Tropical Knitex Ltd (Extension)

24-Sep-2023

Observations

Beam layout plan

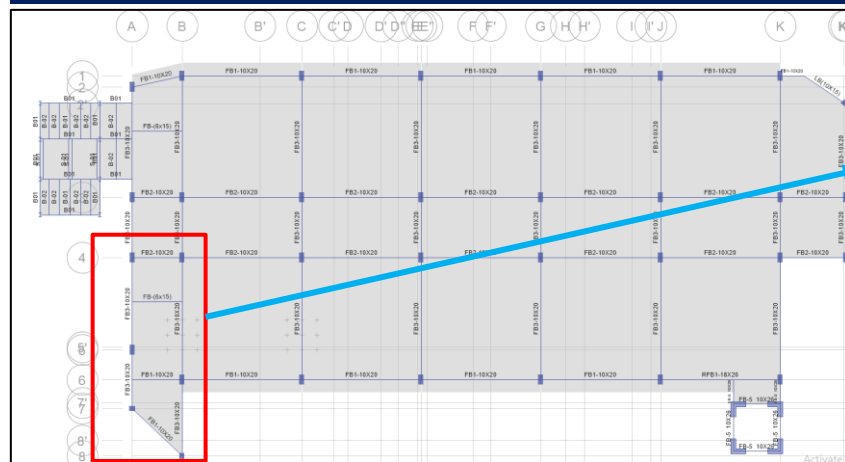
The Beam was not found at site

The Beam was found at site

Mismatch found between as-built drawing and actual site condition. Beam was not found at red marked location. Besides, beam was found at green marked location. Also, in FEA model the same mis-match observed.

Factory Engineer is required to survey the whole structure and update as-built drawing. Revise the Detail Engineering Assessment based on actual site condition.

Beam Assignment in FEA model

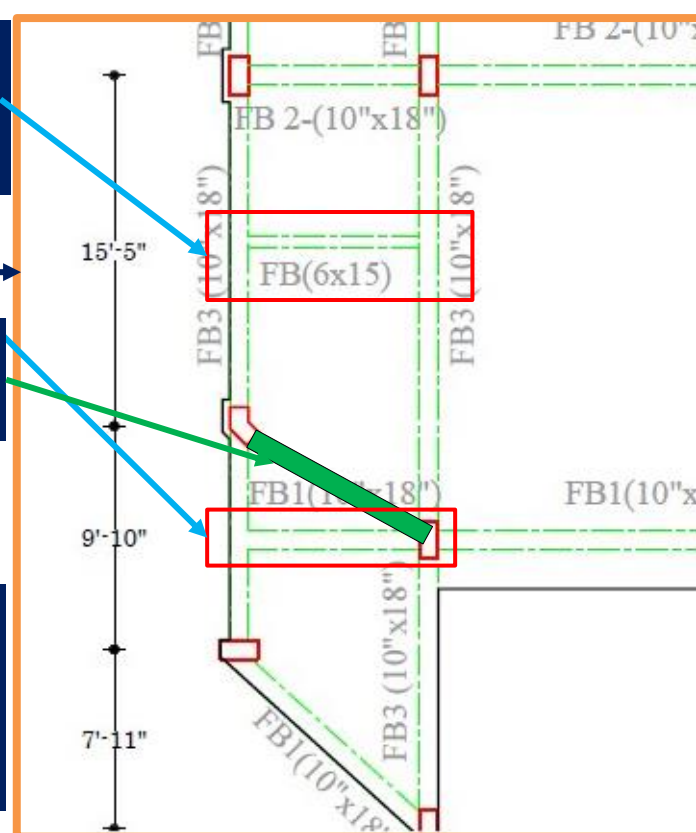
Beam assignment in FEA model do not match with site condition

4th floor Beam layout plan

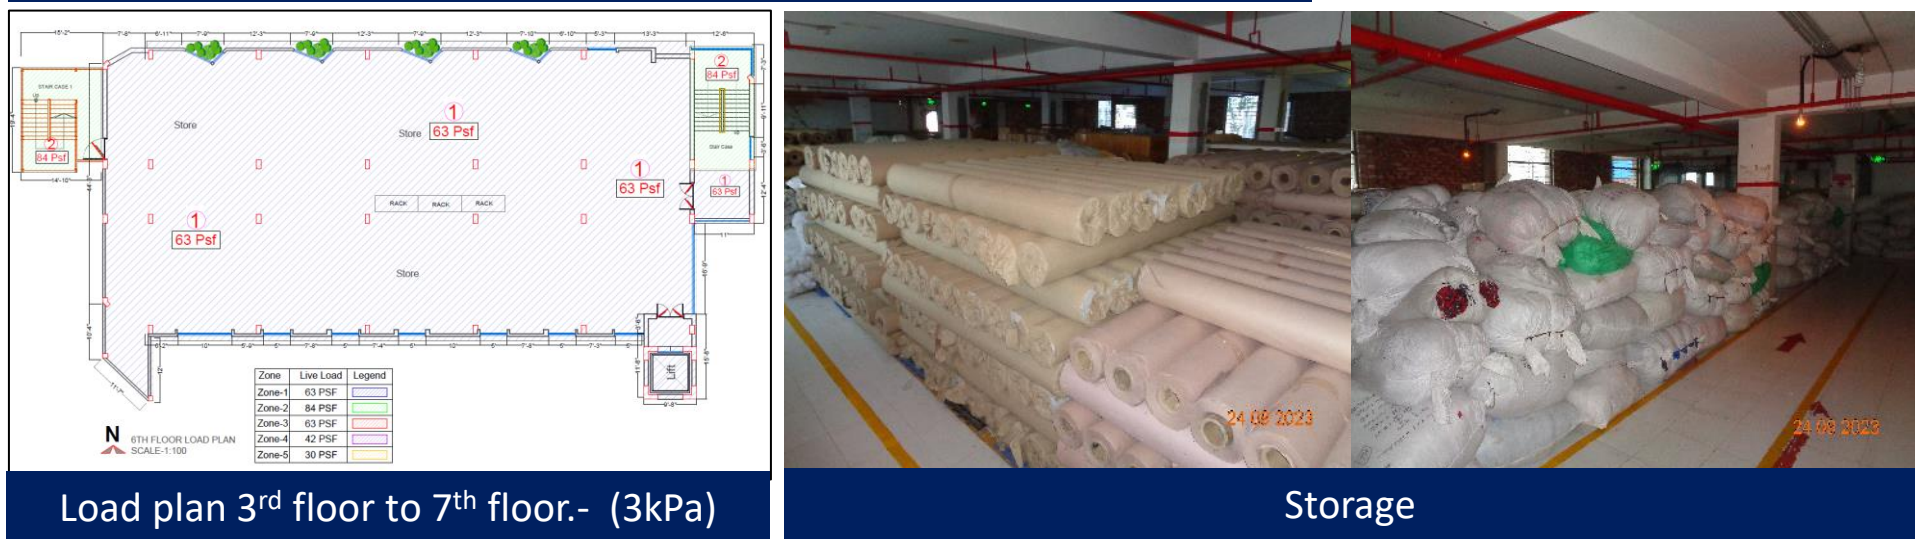
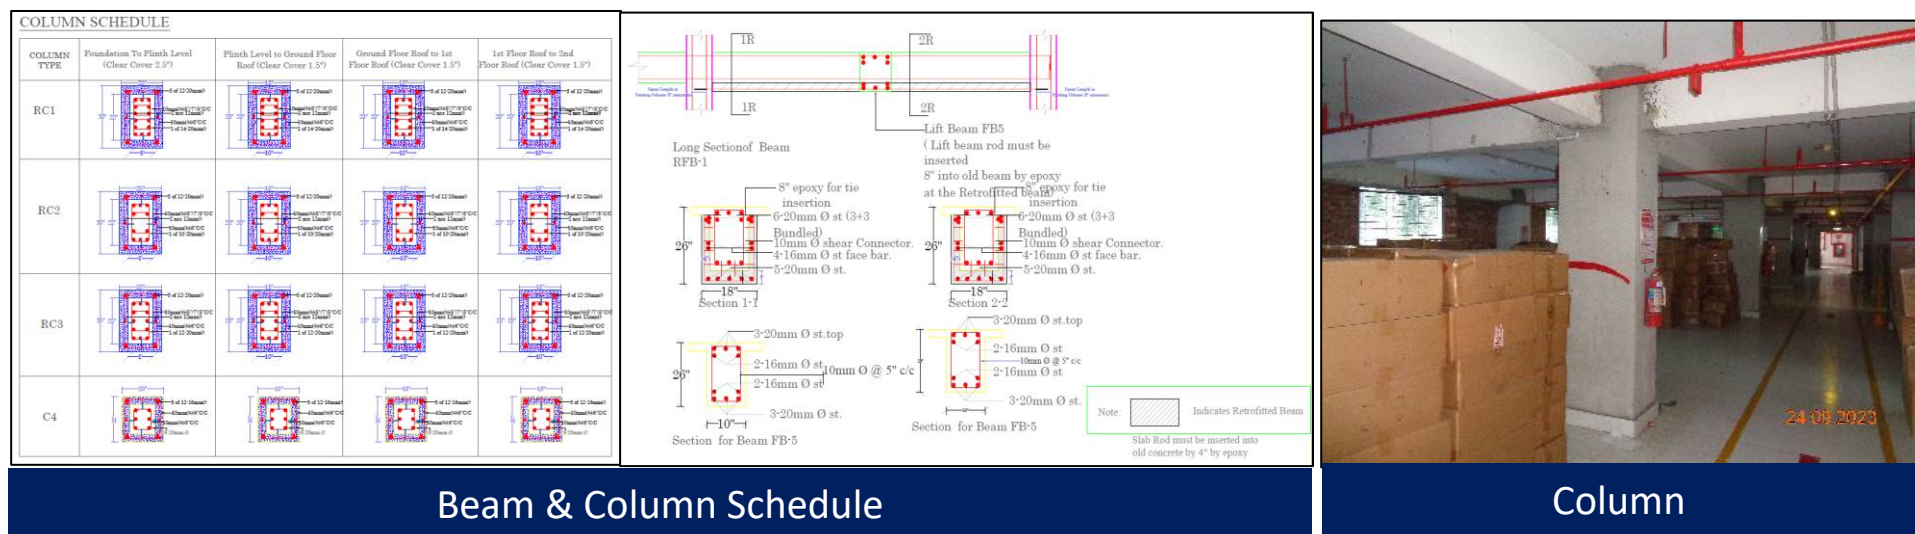
Additional panel with beam-slab and column was found at 4th floor which has not been shown in as-built drawing.

Stair roof top details of the roof top has not been provided in as-built drawing.

Exposed re-bar at roof and corrosion in steel stair

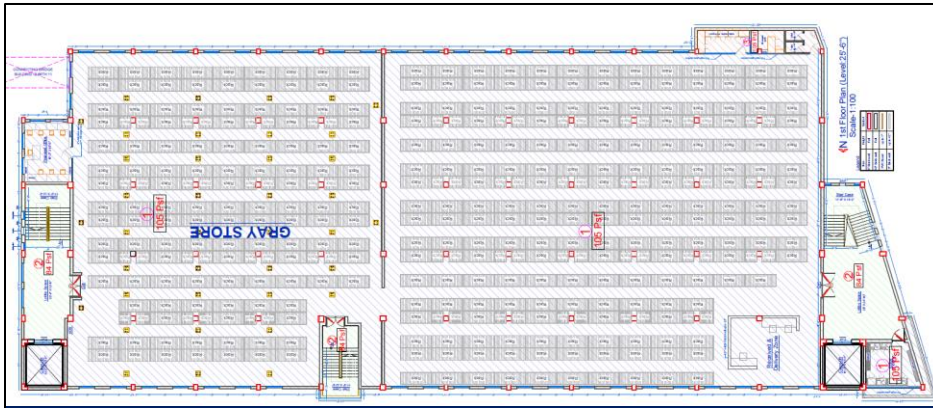
Exposed re-bar head of column at roof susceptible to corrosion and potential to damage of the structural members. Factory is required to take necessary measures to protect the re-bar from corrosion.

Appearance of corrosion was found in the steel stair. Factory is required to repair the corrosion and apply rust proofing on the corroded areas to protect the steel members from corrosion.
